**P-05-886 - Stop the Red Route (A55/A494 corridor), Correspondence –  
Petitioner to Chair 19.06.19**

**Petition calling on the National Assembly of Wales to urge the Welsh  
Government to withdraw its support for the “Red Route” (A55/ A494/ A548  
Deeside Corridor Improvement)**

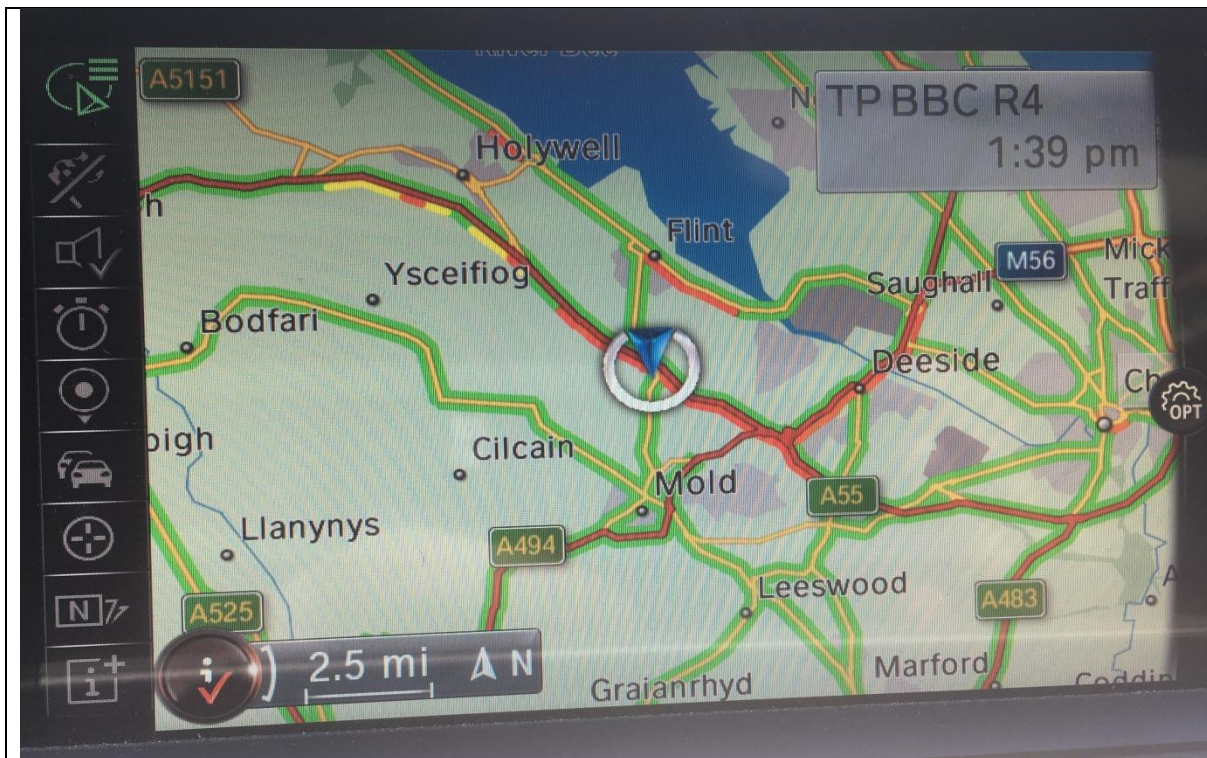
The main reason for the holdups is that there is a long hill west out of Northop towards Holywell (see figure 1). We note from the Minister's letter he concedes that this is an issue, but that there is no firm commitment to a 3<sup>rd</sup> (crawler) lane on this hill to help alleviate this problem. A persistent problem linked to the hold-ups on the section of the A55 between the Ewloe Interchange and Holywell are major traffic hold-ups in Flint (as shown in figure 1).

We are surprised to note that the traffic forecasts and journey times provided in the consultation do not appear to consider the impact of the hill westbound, despite its proximity to the proposed Northop Interchange (see figure 1 below).
